CONSTRUCTION SUMMARY

Forestside Estates Inc.

LOT NUMBER PHASE HOUSE TYPE CLOSING DATE 320 BLOCK 2 6-III Holly 2C 13-Apr-23

Lot: 320 BLOCK 2 Project: Forestside Estates Inc. Model: Holly 2C

BUILDING A SUITE 320 BLK Z

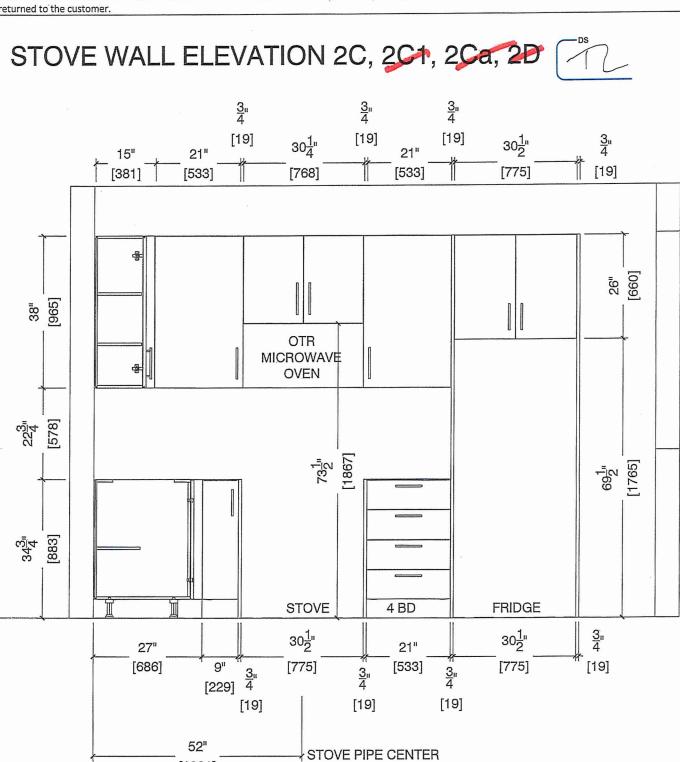
- 1 KITCHEN & BATHROOMS Purchaser has DECLINED All Upgrades offered during decor appointment at the decor centre for kitchen & bathroom cabinetry. Standard Kitchen Layout & Standard Bathroom Vanities to be installed as per standard plan. (See Sketch) Note:
- 1 KITCHEN- PLUMBING -Kitchen Faucet STANDARD- DELTA Chrome Osler Pull Down Kitchen Faucet (Single Hole) Model # 976 LF
- 1 KITCHEN- PLUMBING Install the UPGRADED UNDEROUNT SINK in the kitchen- Install the BLANCO QUATRUS R15 U2 Model # 401519 in lieu of the builder's standard kitchen sink. To include cut and polish (see sketch)
